651S-1
GENERAL PURPOSE HF RECEIVER

PUB NO.	NOTE	DATE	SUBJECT
IB 1-72 ✓		03/01/72	Subassembly Interchangeability
SB 1		10/01/72	Reduction of 450-kHz Leakage From Synthesizer Reference Board All
SB 2		06/06/73	Reduction of Noise Level
SB 3		07/15/73	Add Keep-Alive Frequency Memory Function
SB 4		07/15/73	Extend Comma and Decimal Lamp Life in Frequency Display
SB A ✓		11/01/73	Change DCFE Filter Switching Diode
SB 5	1	12/15/74	Minimize TCU Circuit Card Response to Data Link Noise and Failure
SB 6	2	03/01/75	Reduce Intermodulation Level
SB 7		02/07/75	Reduce Internal Spurious Signals
SB 8		12/27/74	Allow Remote Control Operation With RS-232C Serial Control Interface Card A9
SB 9 ✓		02/15/75	Increase Life of Display Tubes
SB 10 ✓	2	12/31/75 Revised 08/02/76, 04/01/77	Replacing Display Tubes With LED Plug-in Assemblies
SB 11		Not issued	
SB B ✓		11/15/74	KAV
SB C ✓		01/15/78	Supply KAV Power to DCFE
SB 12 ✓		05/01/78 Revised 07/01/78	Replacing Nonprocurable Integrated Circuits

SERVICE BULLETIN A

SUBJECT: Change DCFE Filter Switching Diode

Location of CR26
Figure 2

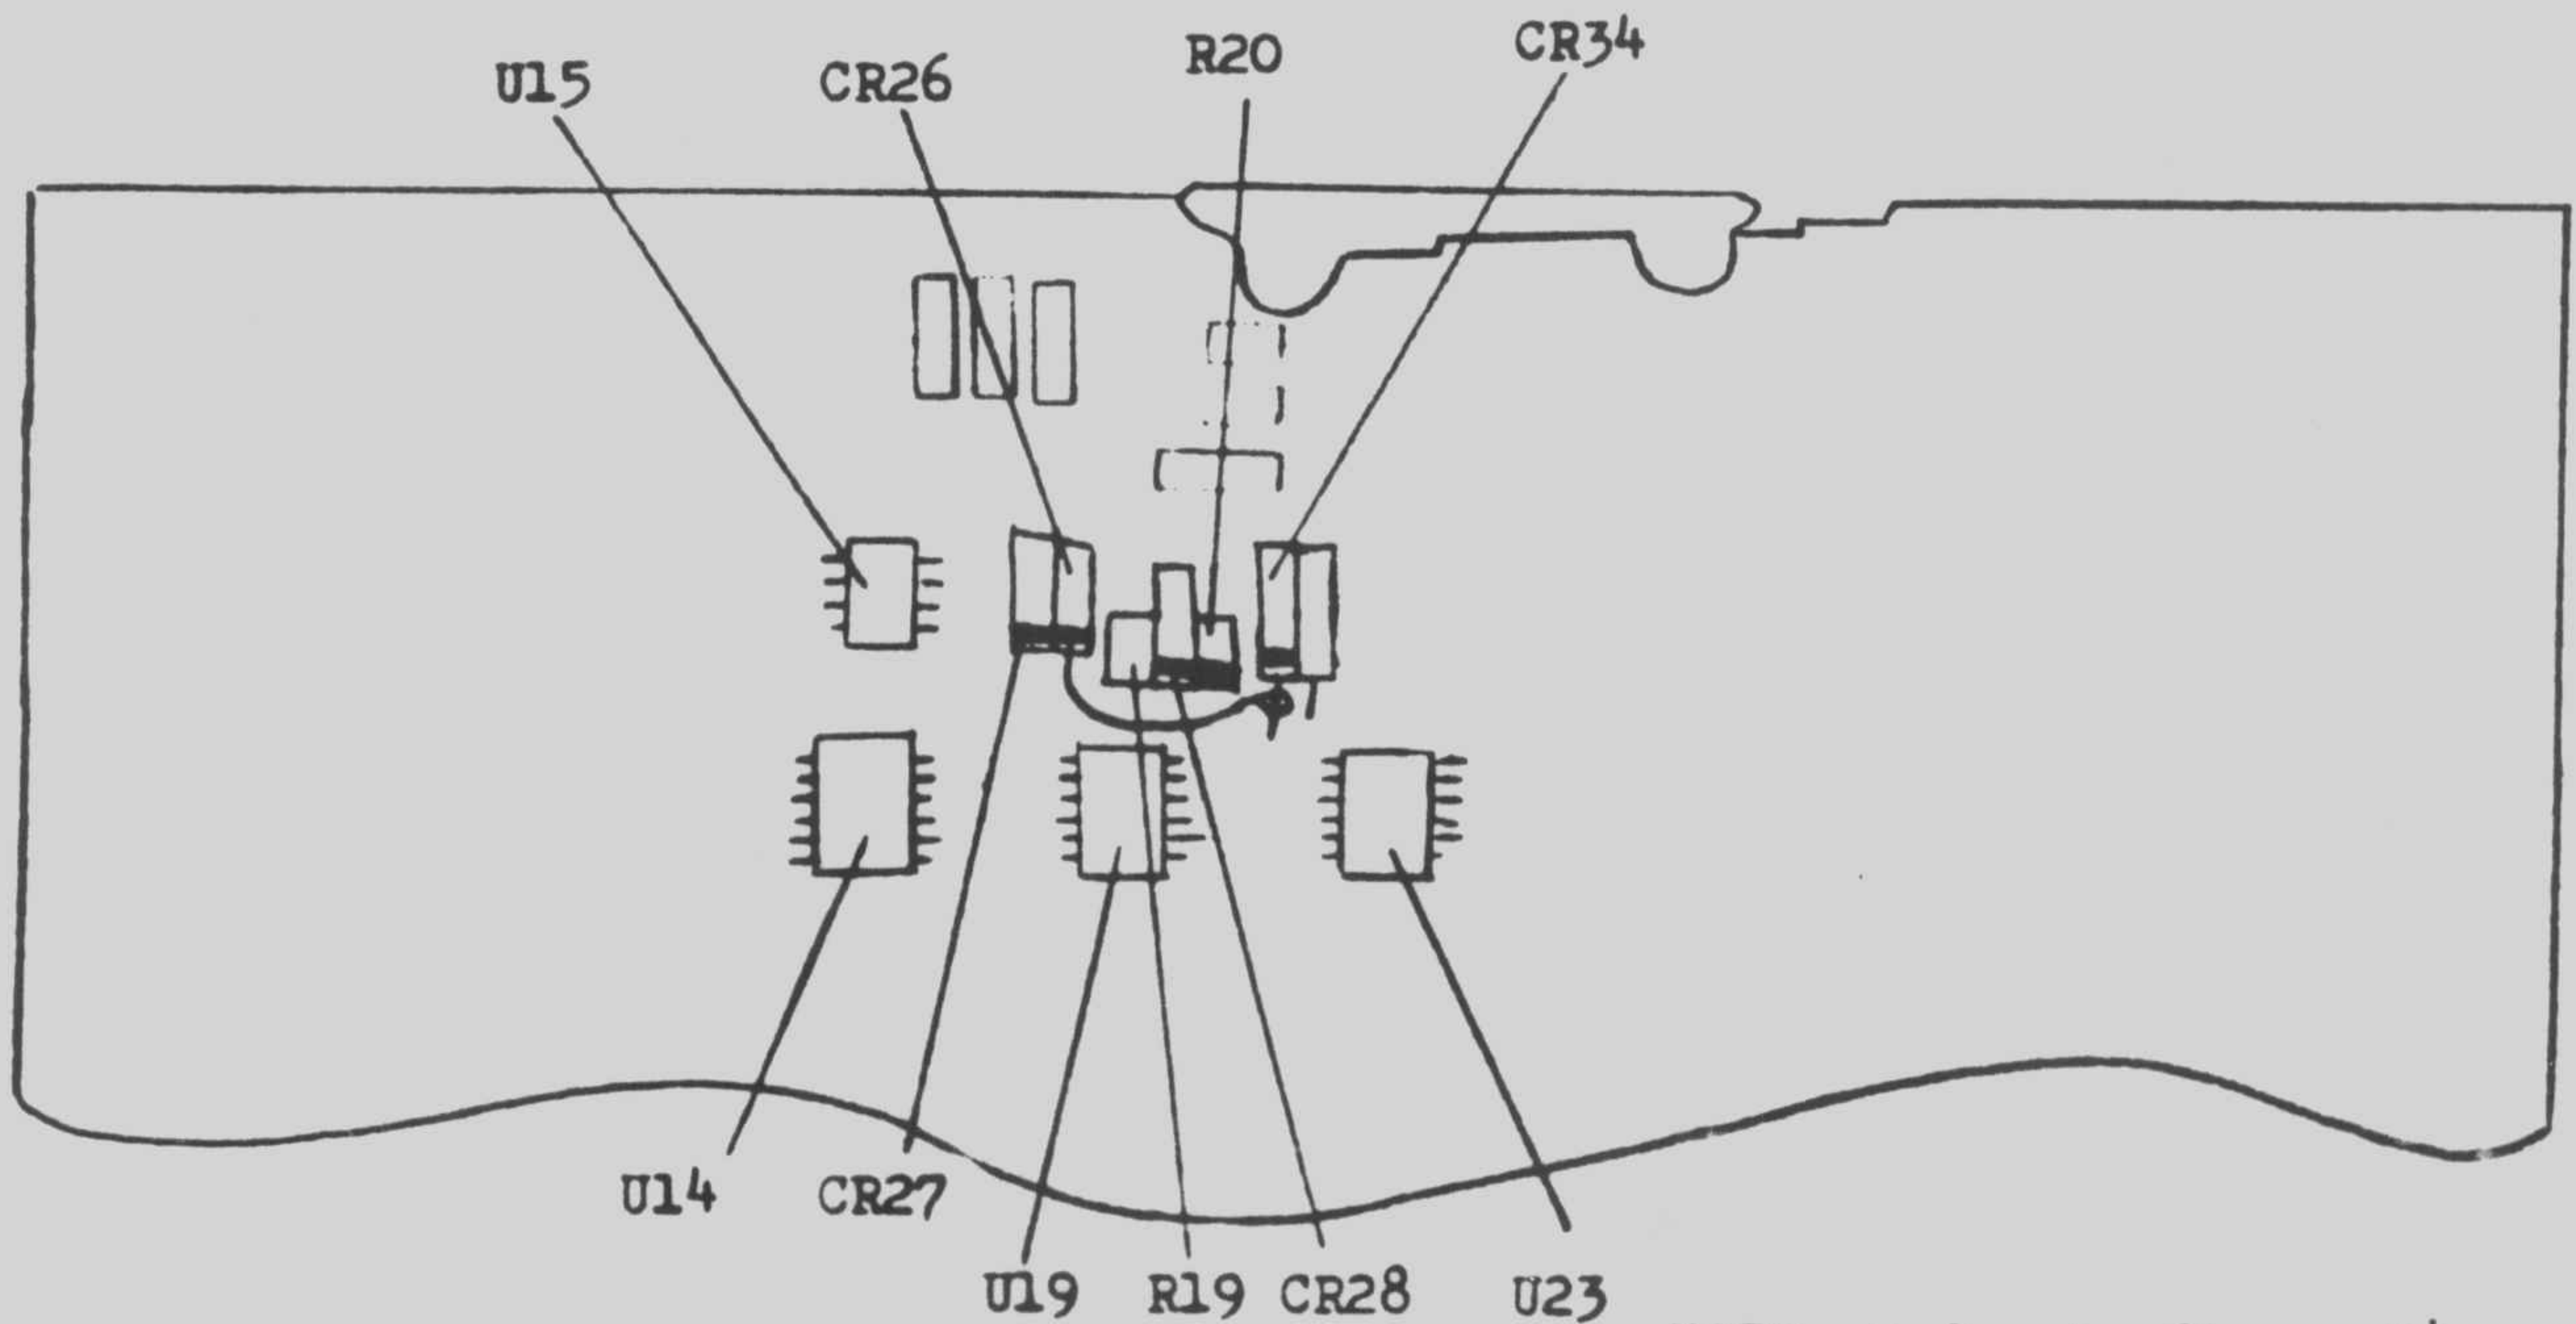
- a. Remove the DCFE card from the receiver.
- b. Locate, note position of anode, unsolder and remove diode CR26. Discard old diode, as its leads are too short for new mounting. Refer to figure 2.
- c. Install and solder the anode end of the new diode in the same position as the anode of the original diode. Refer to figure 1.
- d. Slide sleeving on the cathode lead of the new diode. Wrap the lead on the cathode lead of diode CR34 and solder.
- e. Mark circuit card "RWK-002" to indicate that it is electrically the same as the new part number 624-5744-002.

TCU Circuit Card A9
Figure 1.

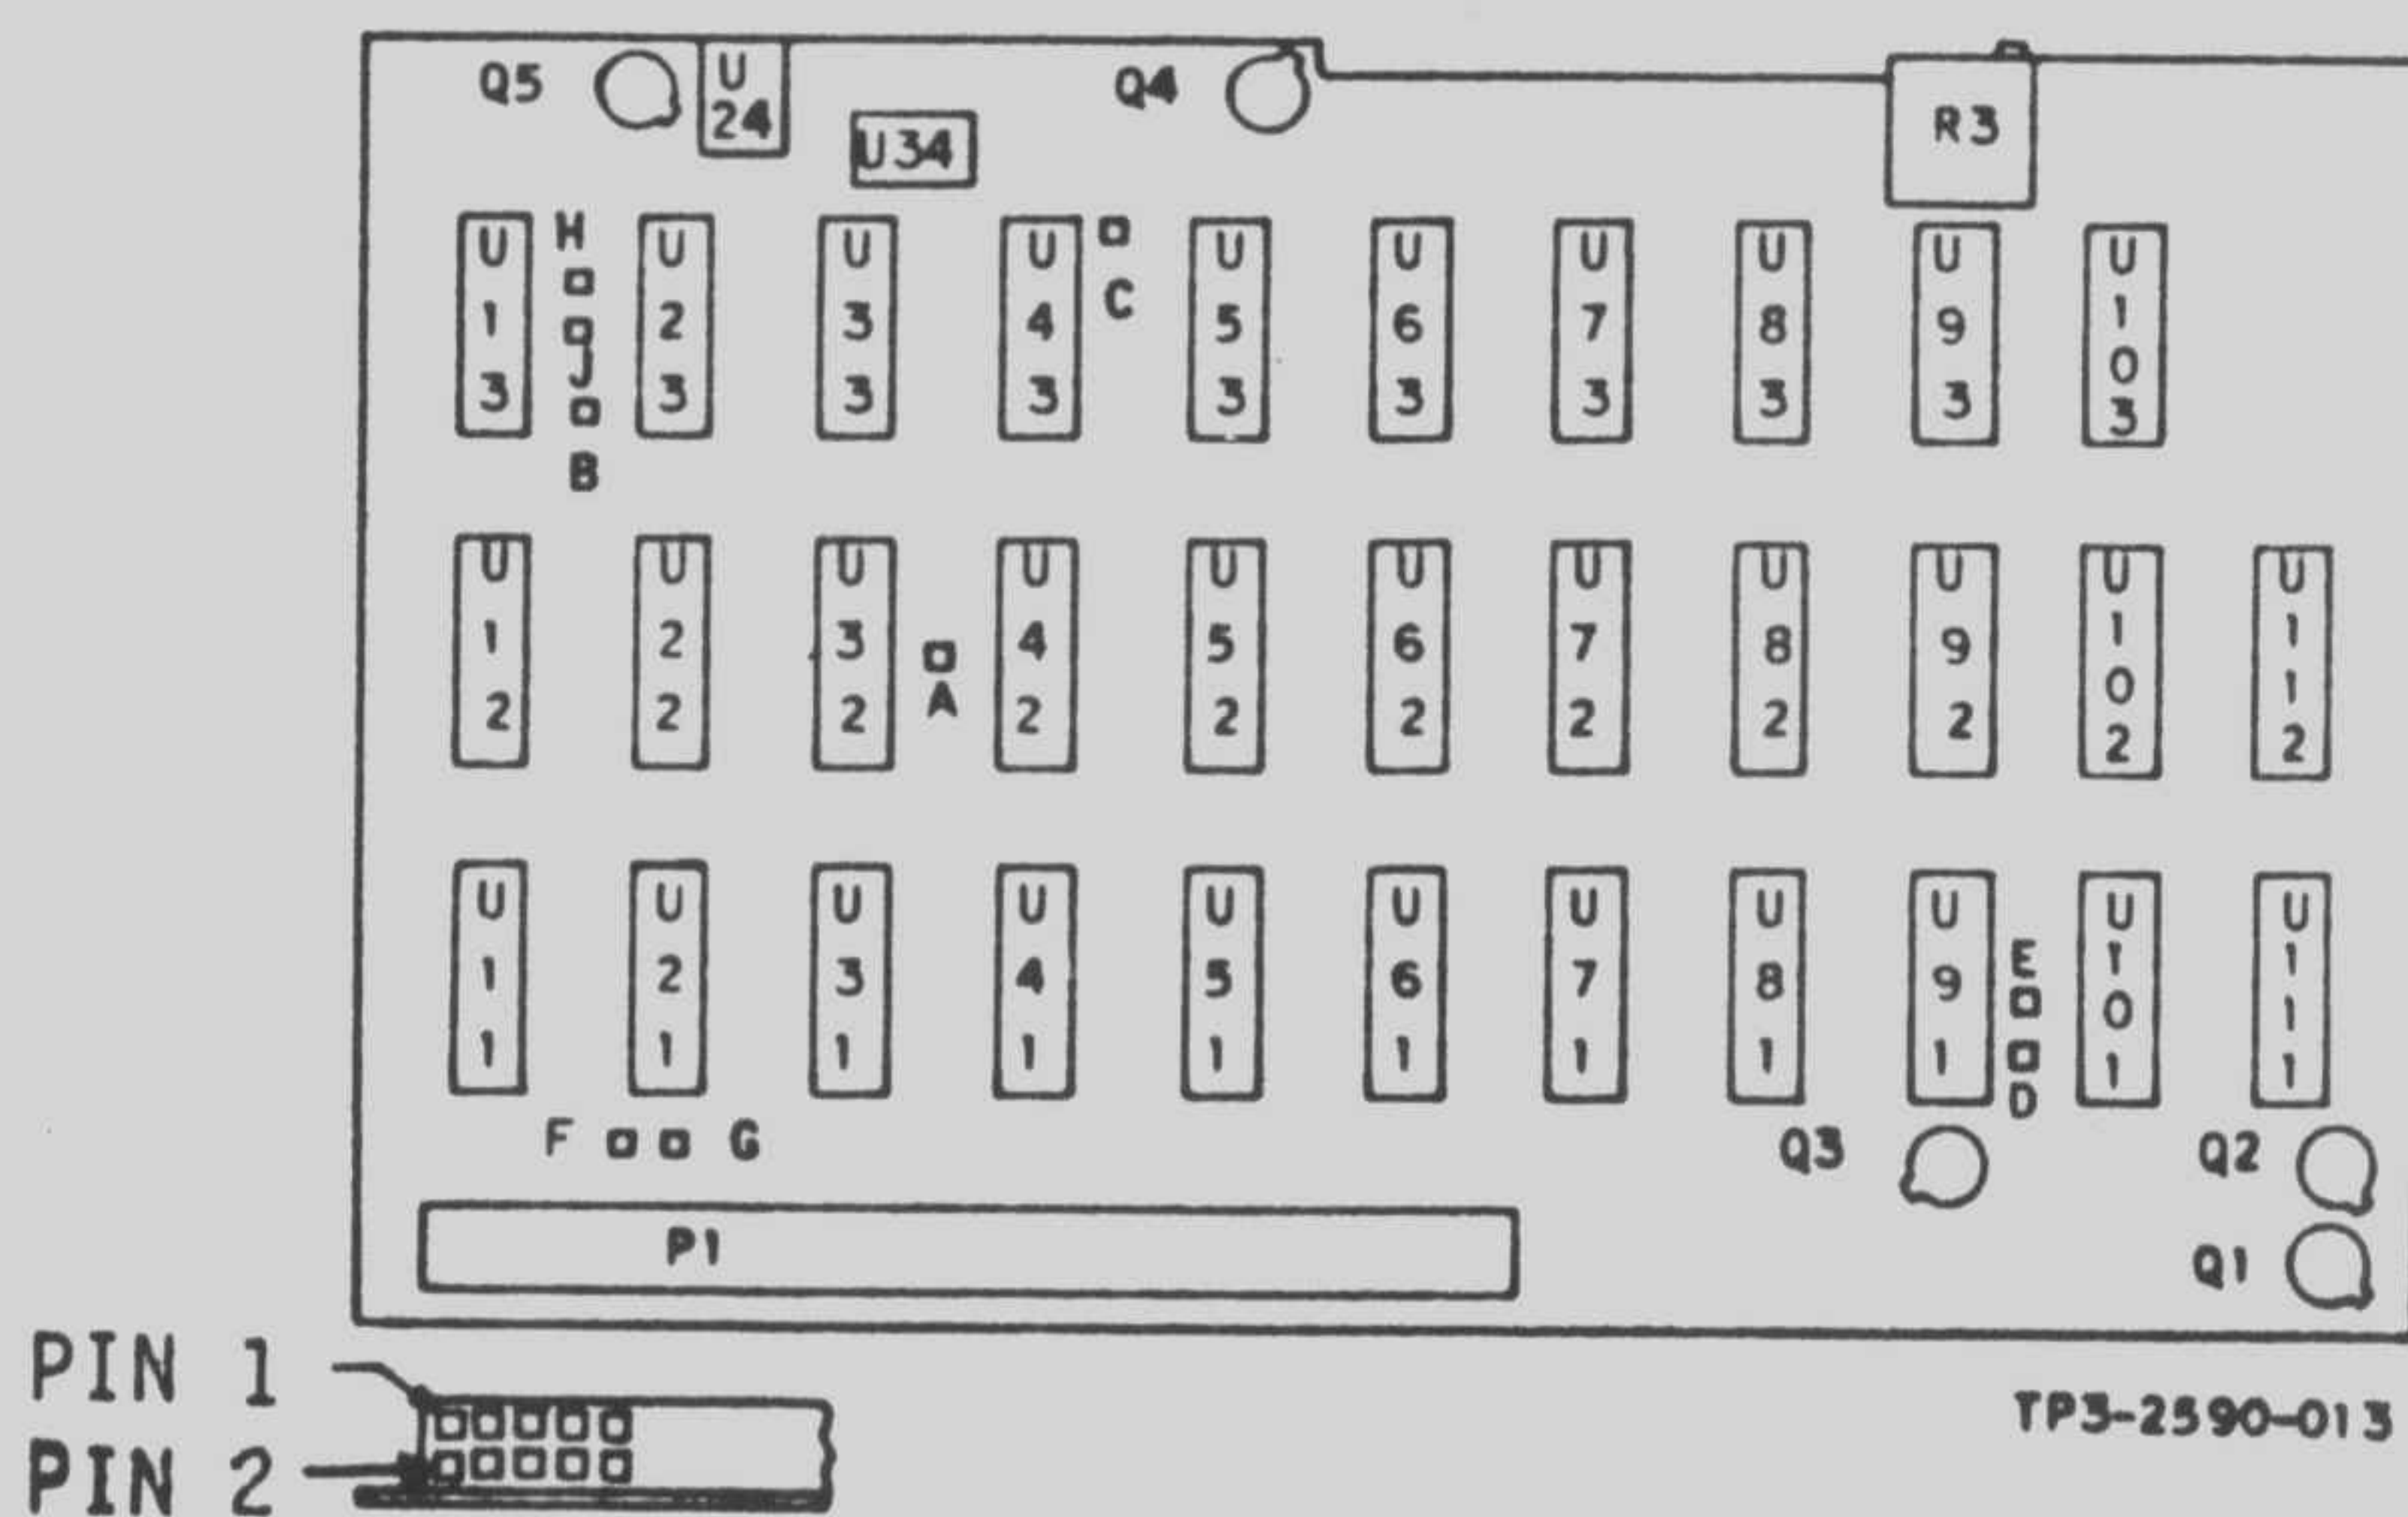
- c. Remove TCU card A9 from the receiver.
- d. Remove connector sockets 35 and 36 from connector shell and card as follows: (figure 1):
 1. On the back of the card, suck the solder from the holes occupied by sockets 35 and 36.

2. Using a scribe, or a similar tool, carefully remove the contacts from the holes and slide the contacts out of the blue-line connector.
- e. On the back of the card, solder one end of a jumper (428-4821-000) in the hole where socket 35 was located.

- f. Wrap and solder the other end of the jumper around the contact lead of socket 22.
- g. Mark "SB B" on the TCU card near the part number.
- h. On the bottom of the 651S-1 chassis sideboard, connect a jumper (428-4821-000) from J1-17 (mates with A14 connector) to J30-22 (mates with A9 connector). Refer to figure 2.
